Tintenbar to Ewingsdale

Upgrading the Pacific Highway

Environmental Assessment
Submissions Report and
Preferred Project Report

May 2009

Figure 4.1j Preferred project

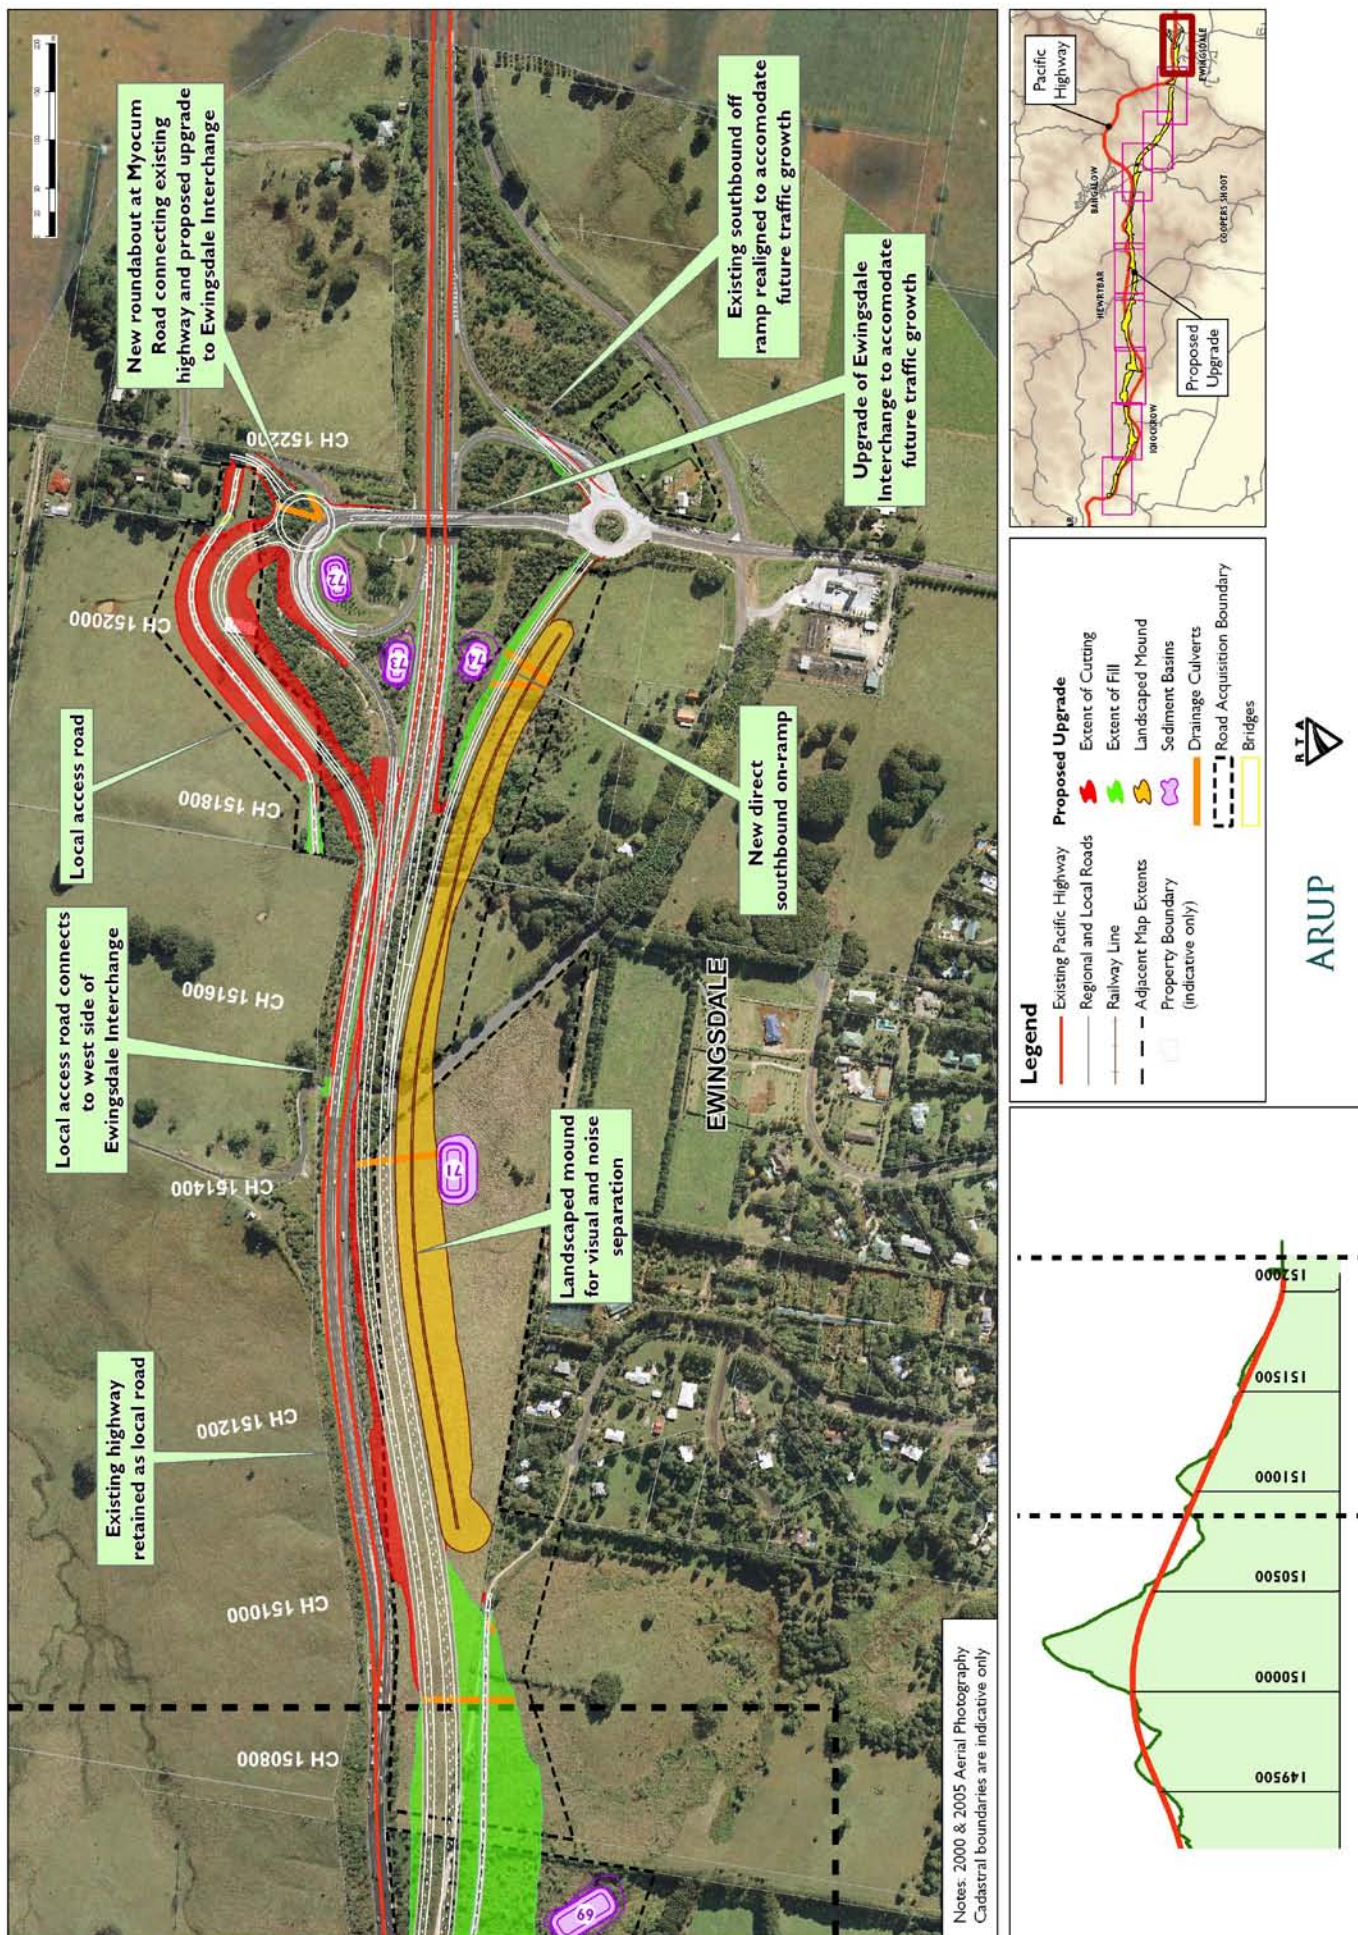
- > Concern over increased traffic on local roads
- > Concern over potential increased noise impacts.
- > Concern over visual and light spill impacts.
- > Questioning of the justification of the interchange in light of the projected level of use.

After further detailed consideration, the RTA has determined that the Ivy Lane interchange be removed from the proposed upgrade. The removal of the interchange is discussed in detail in Section 4.1 as part of the preferred project report.

As well as the interchange itself, the underpass at Ivy Lane would also be removed from the proposal and the local access road arrangements on the western side of the upgrade would be amended to provide access to the properties on that side. The altered configuration is shown in figure 4.1c.

Figure 4.2 Clover Hill landscaped mound - plan

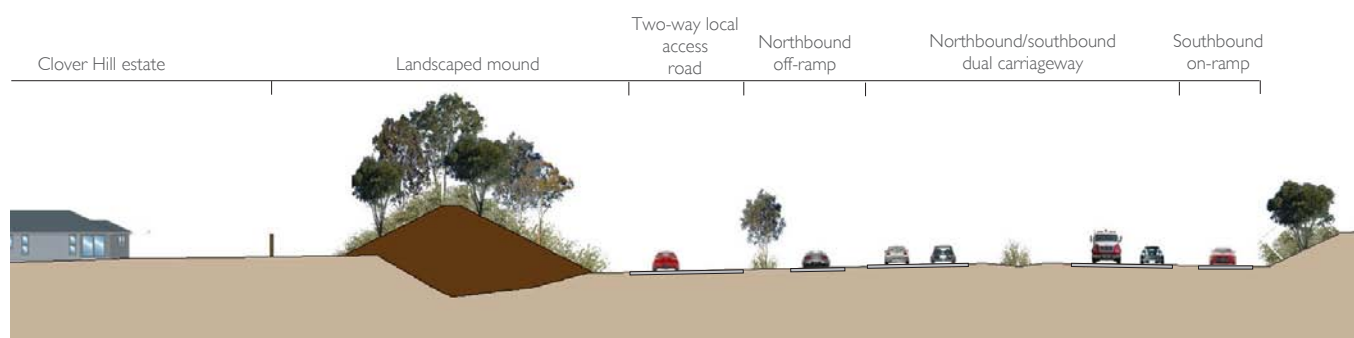
- > By deleting these half interchanges it would improve safety, reduce visual impact and reduce construction costs, and dramatically improve the ability to provide noise mitigation necessary for the adjacent Clover Hill Housing Estate. (281)
- > This proposed half interchange also seems to run counter to RTA guidelines which say that the minimum distance between highway interchanges is considered to be 10 km. A half interchange would be just 6 kms from the existing Ewingsdale interchange, and so goes against the RTA's own rules. (158)

A landscaped mound is now proposed adjacent to Clover Hill estate to provide noise and visual mitigation. Details of the landscaped mound are described in Section 4.3 of this report. The mound would be revegetated as early as practical in the construction program.

Plan and a cross section sections of the landscaped mound is shown in Figure 4.2 and Figure 4.3, while aerial perspectives with and without the mound are shown in Figures 4.4 and 4.5 respectively.
